Nature of Project:
Construct rear stair and roof deck; construct egress area; install 6'7" fence; construct front ramp; restore storefront; remove bars from windows; install new window and door; install rear garage door; install new mechanical units; change paint colors

APPLICATION FOR A CERTIFICATE OF APPROPRIATENESS – STAFF REPORT

COA-0034-2019 517 S BLOUNT STREET

Historic District: PRINCE HALL HISTORIC DISTRICT

NORTH

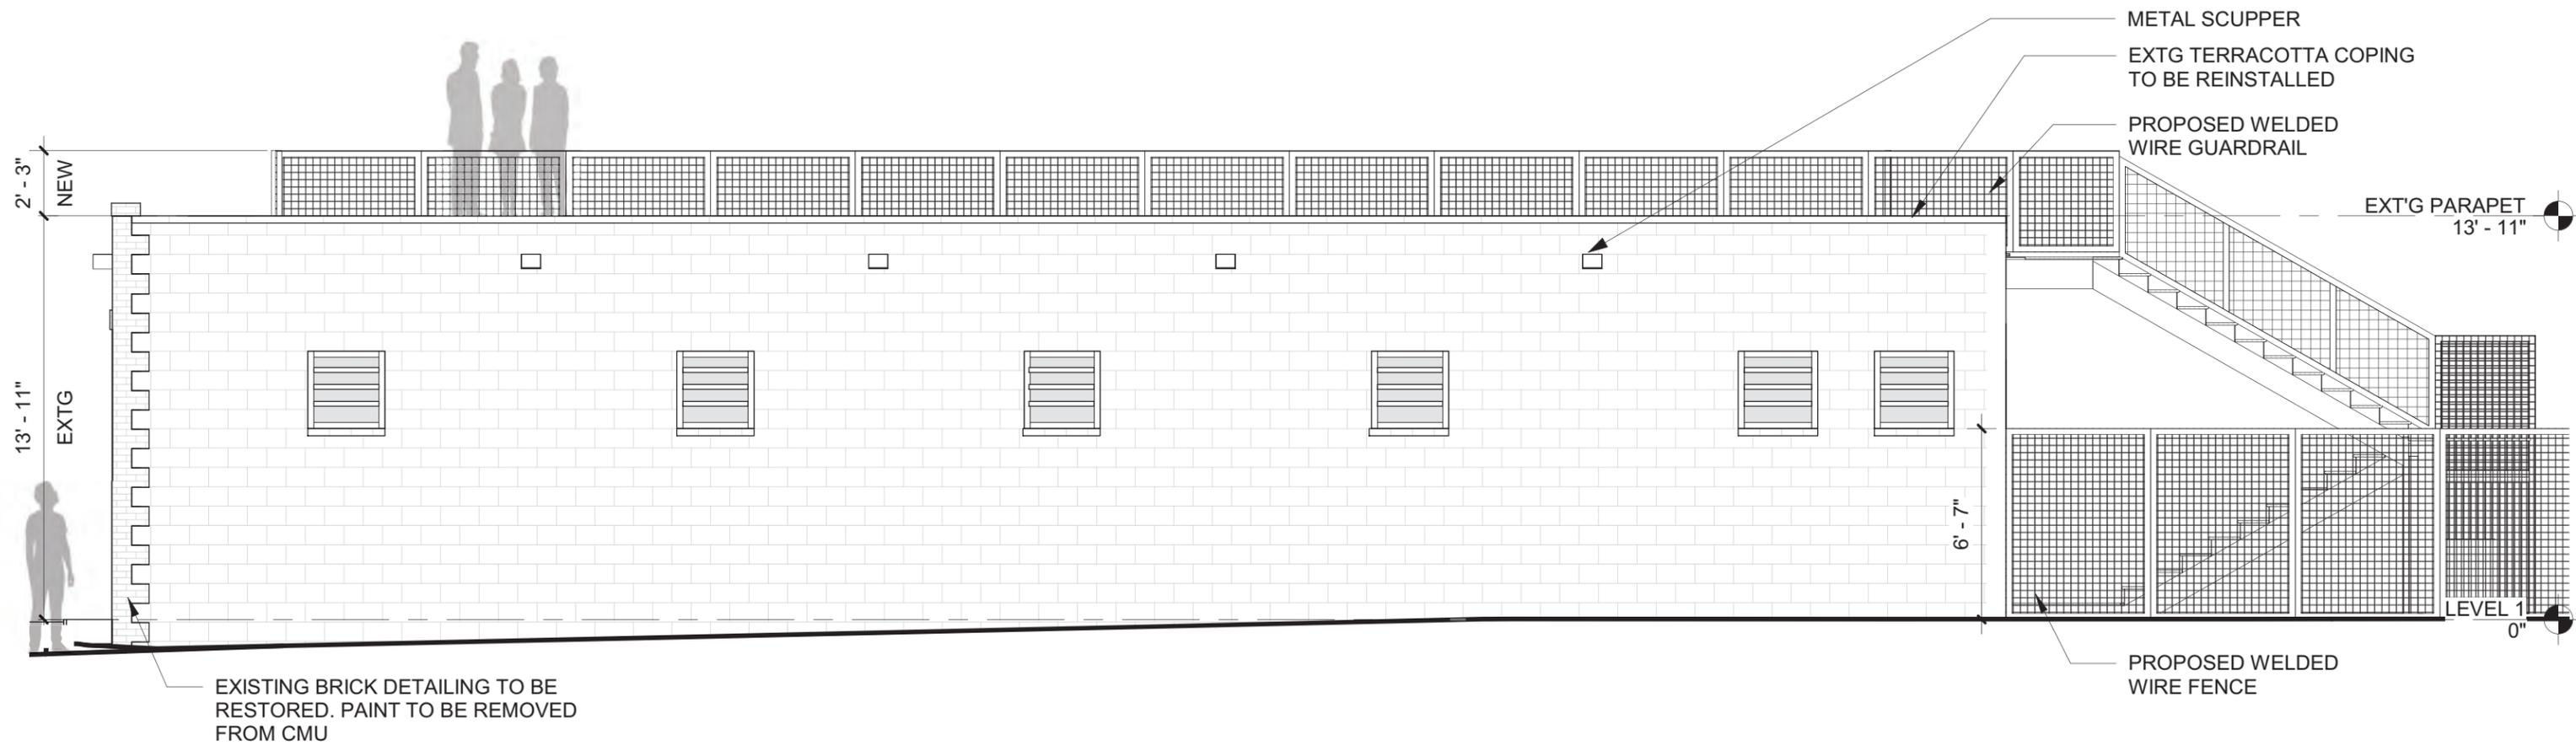
- 5* A door opening that has been blocked off with wood is proposed to be converted into a window. The proposed picture window fills the existing opening. The width of the opening is comparable to the existing windows; however, the location of the opening results in a window that is not in harmony with the existing windows. The proximity of the window to the ground is incongruous and atypical to a historic commercial structure. Window specifications were not provided.

2. That the proposed window on the north façade match the sill height and dimensions of the existing windows.
3. That the terracotta coping be replaced in kind where it is deteriorated or missing.

WELDED WIRE GUARDRAIL AND FENCE DETAILS

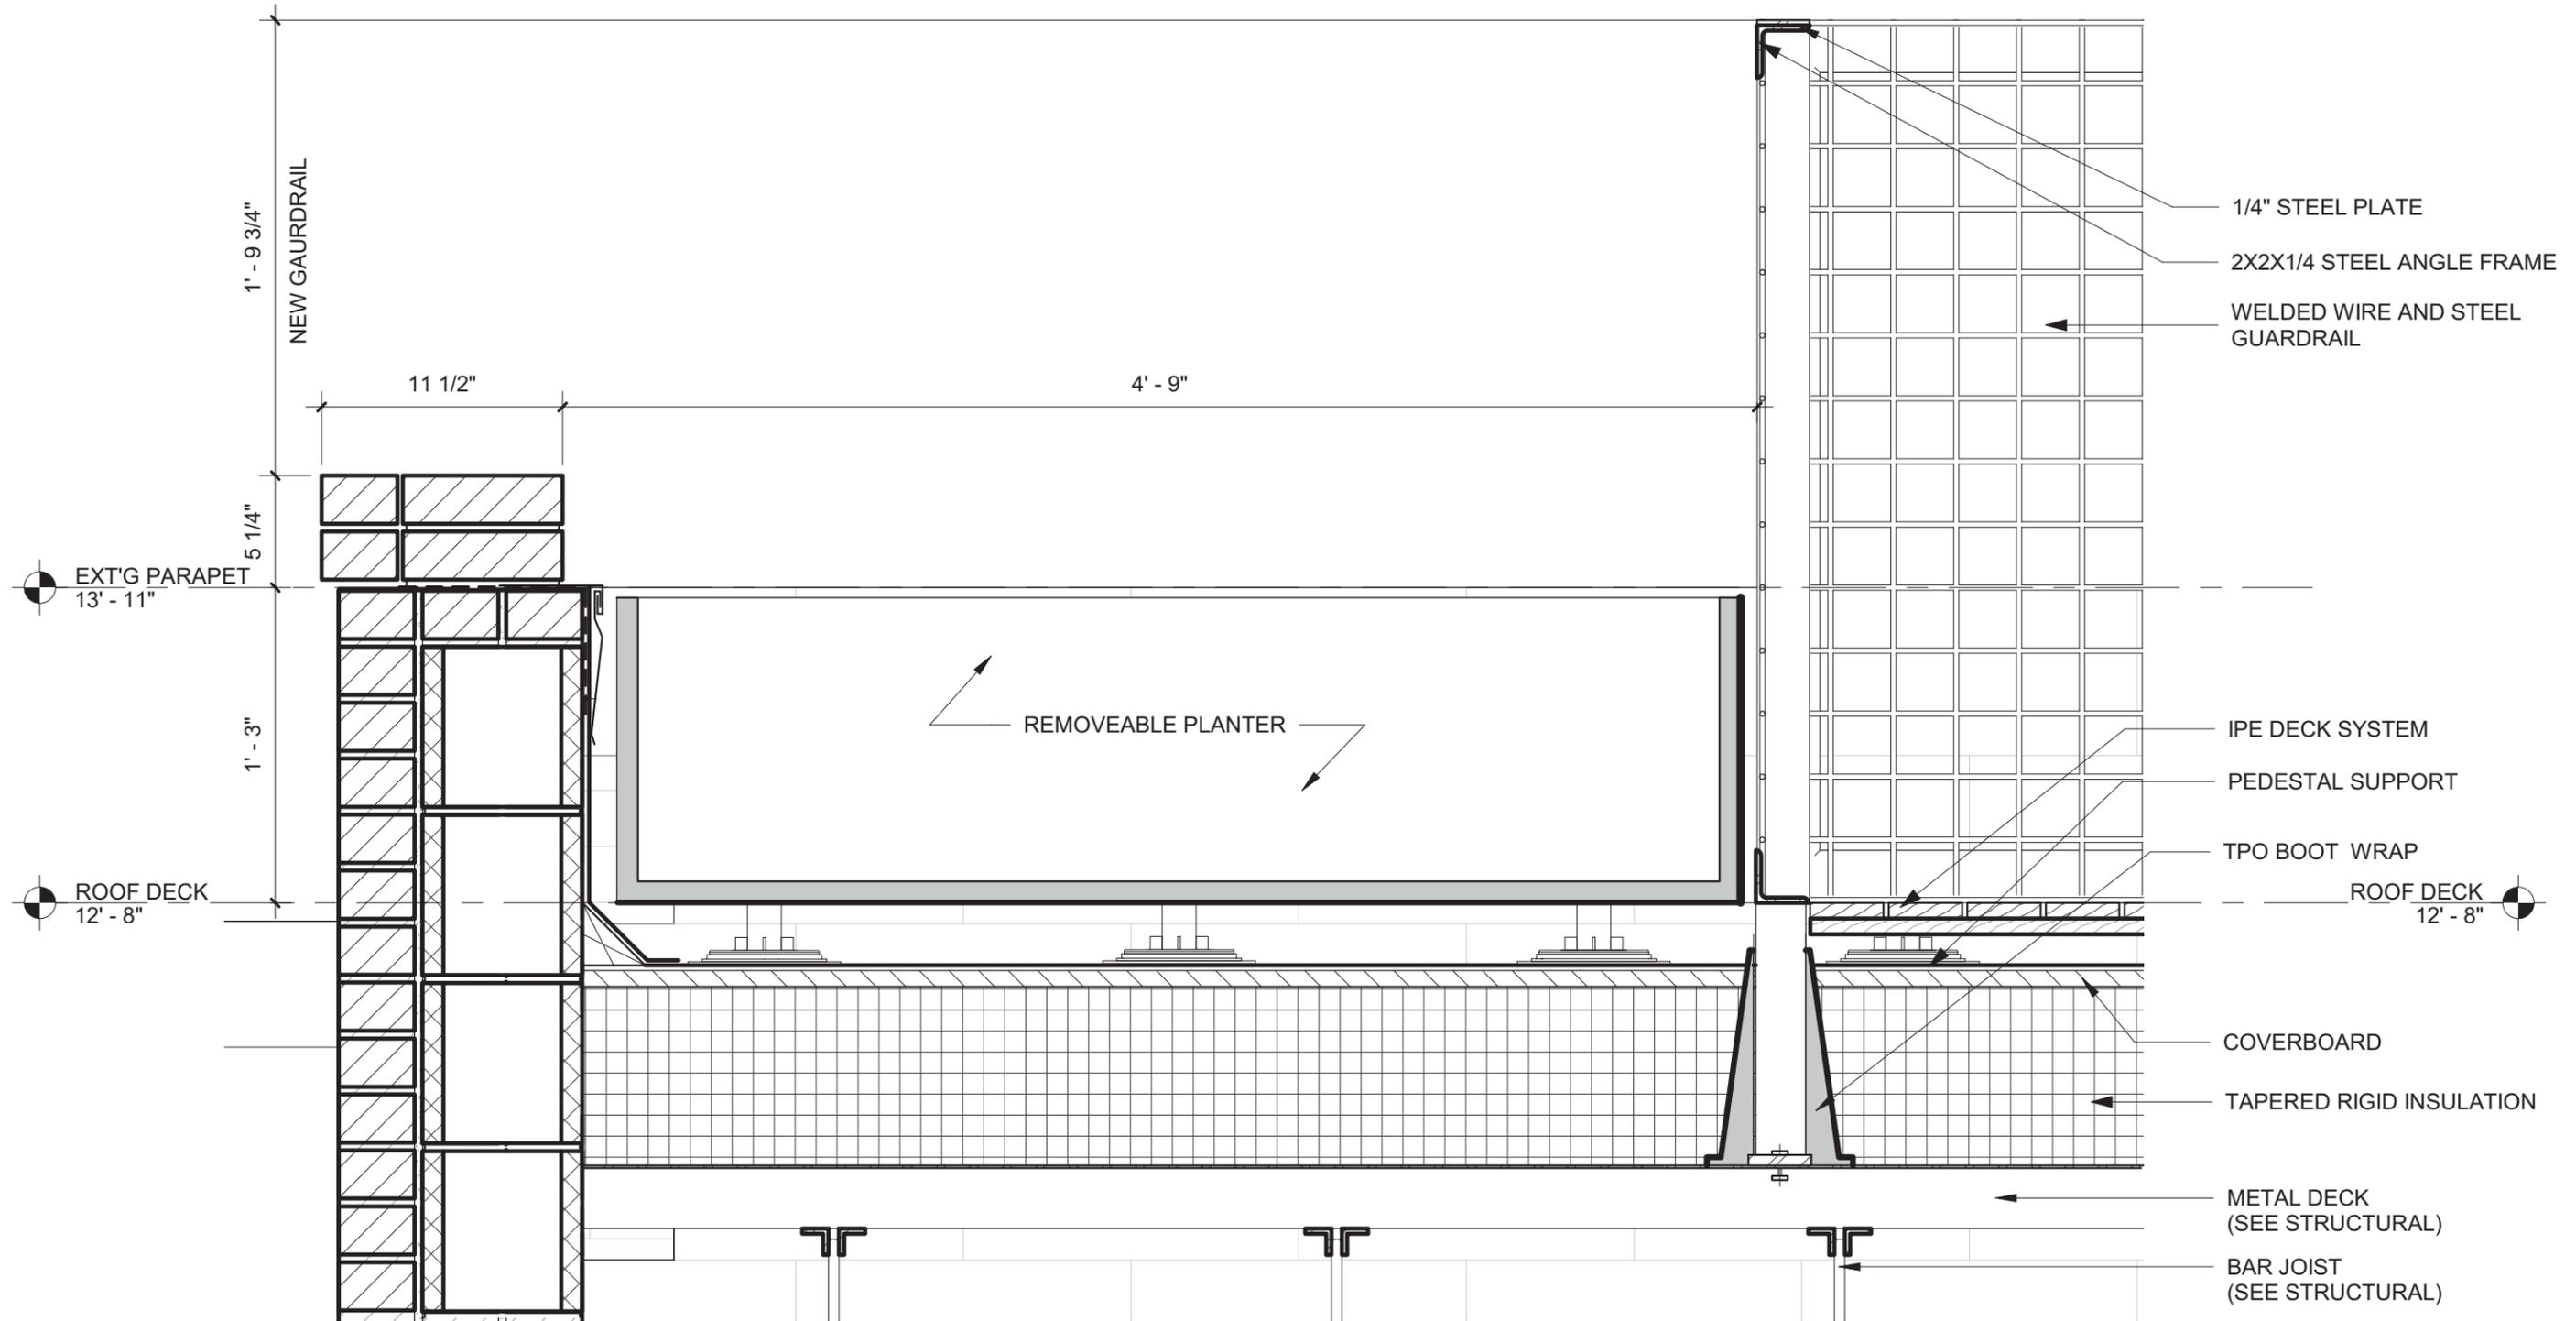
- 10* The railing detail drawing also shows an entity between the railing and the parapet labeled “removable planter;” however, the planter base appears to be mounted to the roof decking using the pedestal system. Unmounted planters are considered furniture and not subject to COA review.

4. That the planters not be mounted to the roof deck.
5. That the fence height be a maximum of 6' tall.
6. That details and specifications for the following be provided to and approved by the commission prior to installation:

WOOD TILE & PEDESTAL APPLICATION

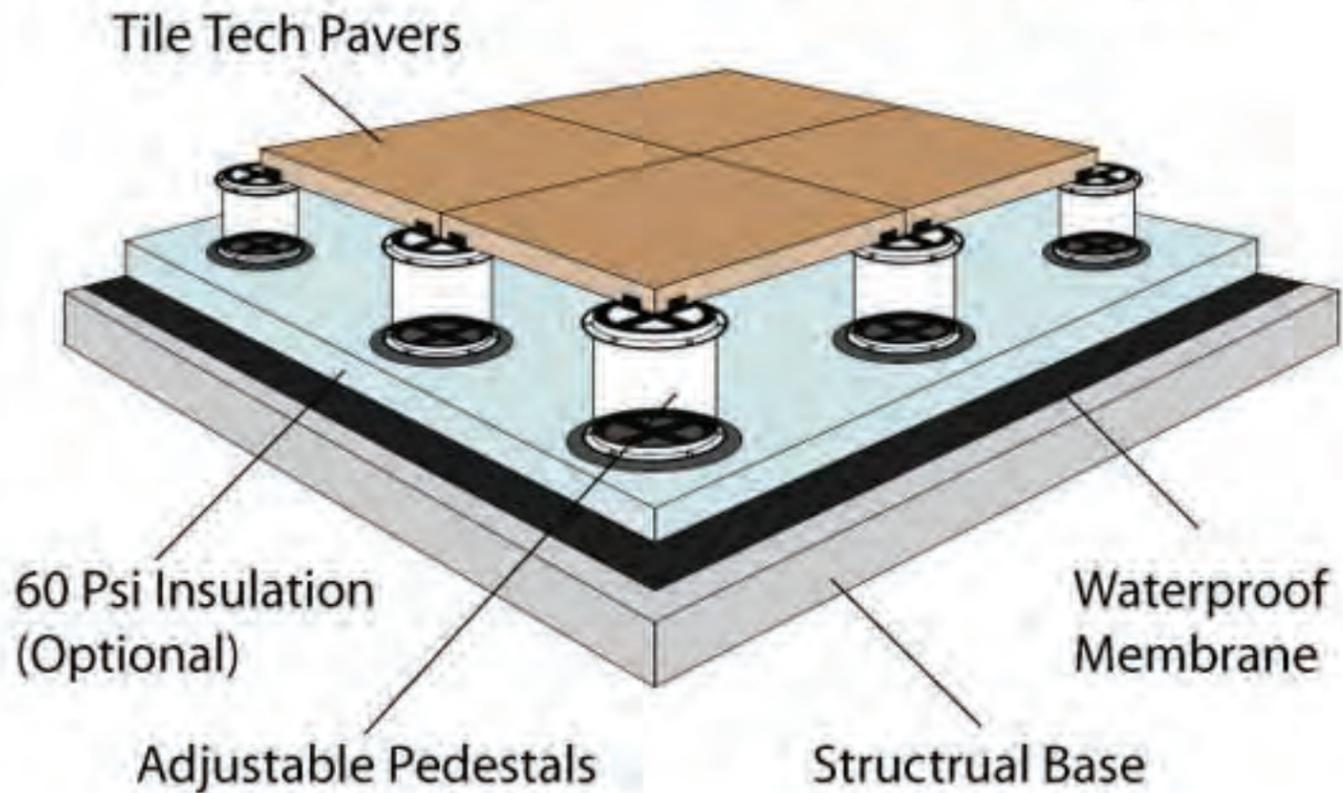
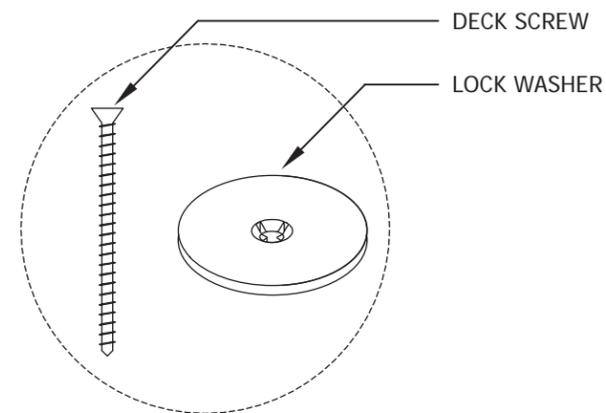
- 5* The application notes that the roof deck utilizes a pedestal system to float over the roof structure. An unlabeled diagram of the pedestals was included. The diagram appears to indicate that each pedestal is screwed into the roof through the pedestal base.
